**UPPER GUADALUPE RIVER
FLOOD RISK MANAGEMENT PROJECT
San José, California**

**DRAFT INTEGRATED
GENERAL REEVALUATION REPORT
& SUPPLEMENTAL ENVIRONMENTAL ASSESSMENT**

Subject: Letter of Support from the Non-Federal Sponsor for the Tentatively Selected Plan (TSP) – Upper Guadalupe River Flood Risk Management Reformulation Study, Santa Clara County California.

Figure 1: Overbanking on Guadalupe River u/s CA-87

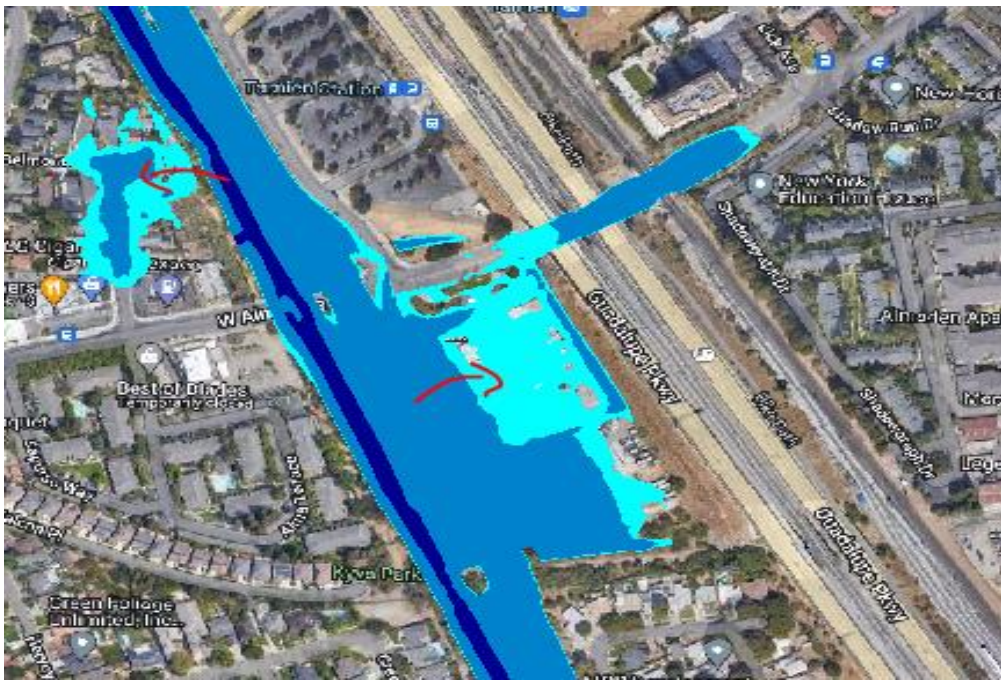
- a. On Guadalupe River, just upstream of CA-87, the left bank (facing downstream) has a small area with low elevation that is spilling water during a 50-year flow, causing a sizeable flooding area and is not addressed in the TSP. Most (if not all) of this area is on Valley Water right-of-way. Optimization efforts in this area could include a short levee or floodwall to contain the flows (see Figure 1).

Figure 2: Overbanking on Guadalupe River near Alma Ave

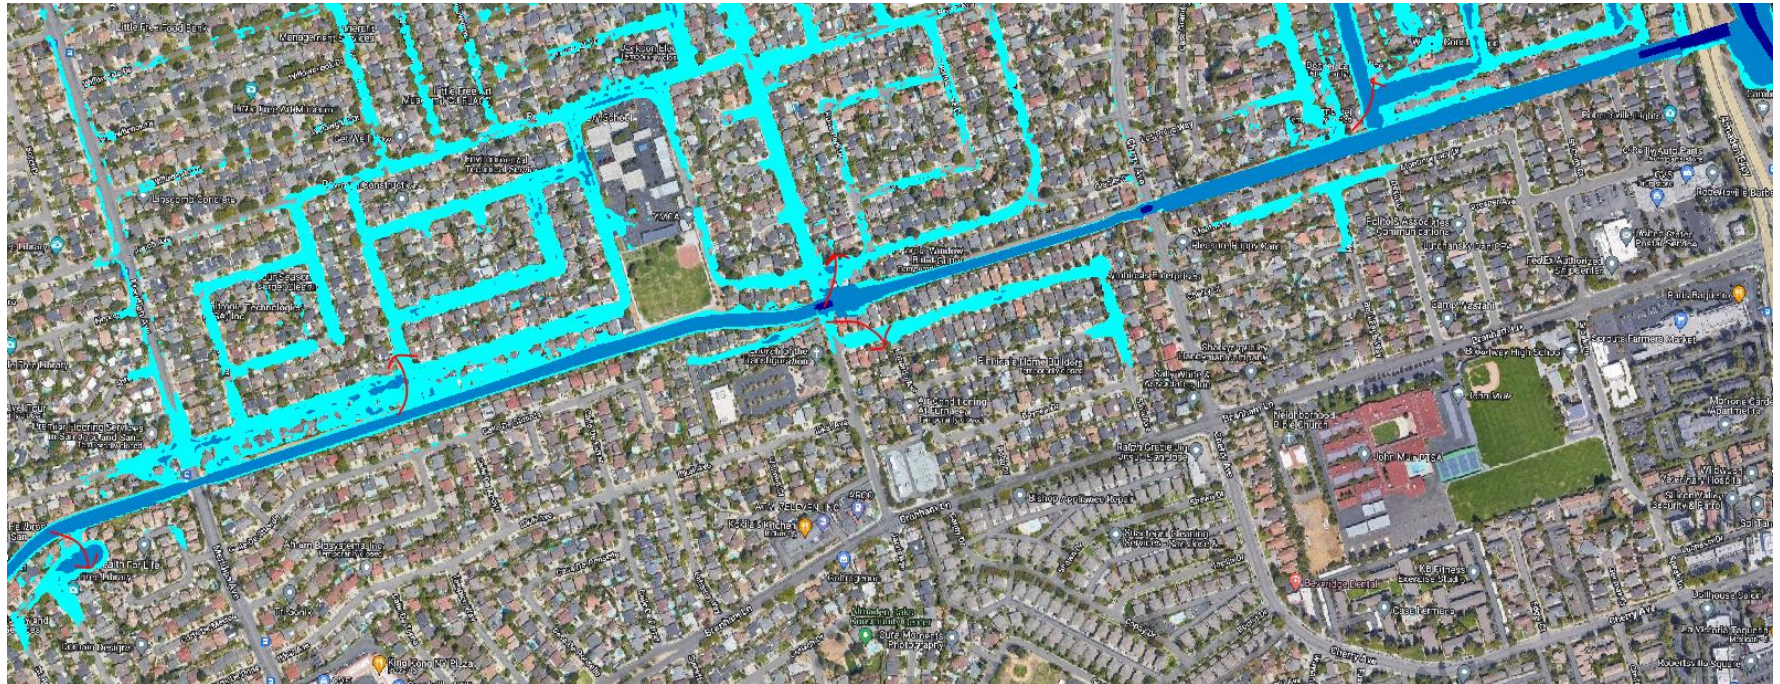
- b. In Reaches 7 & 8 near Alma Avenue, there is localized flooding in the 50-year flow that causes deep ponding. Valley Water owns right-of-way near that location, and it should be possible to construct a levee or floodwall feature to contain the flows (see Figure 2).

Figure 6: Overbanking on Guadalupe River u/s Capitol Expwy (100-year)

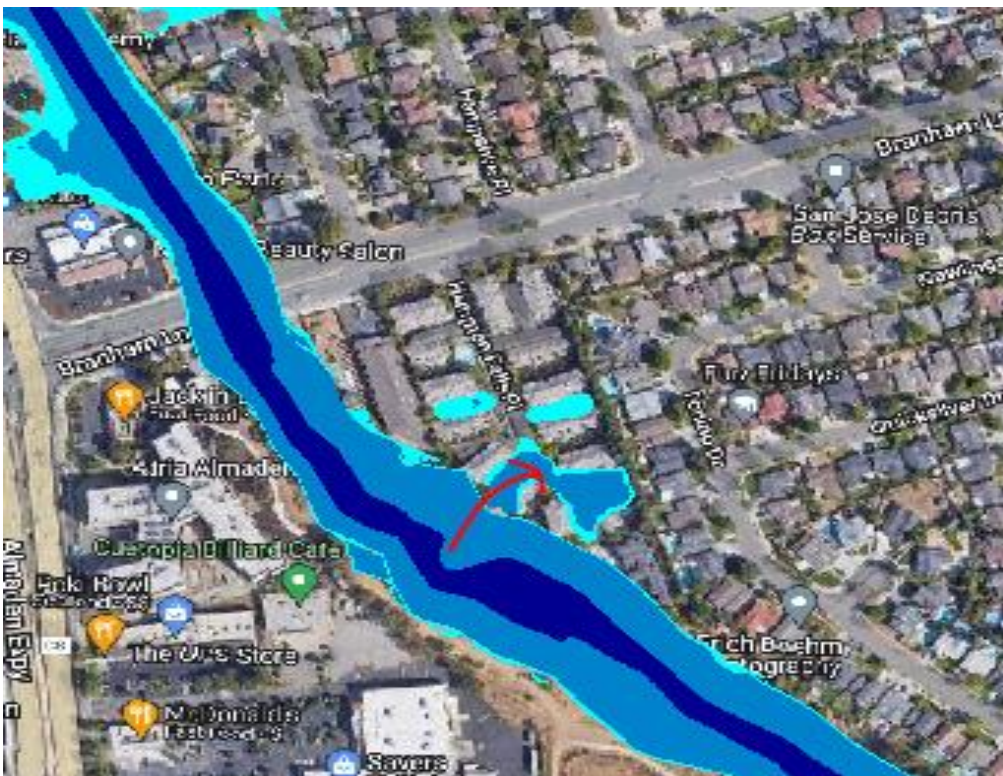
- c. On Guadalupe River, upstream of Capitol Expwy, on the right bank (see Figure 6)
 - d. On Guadalupe River, upstream of Branham Lane, on the right bank (see Figure. 7).
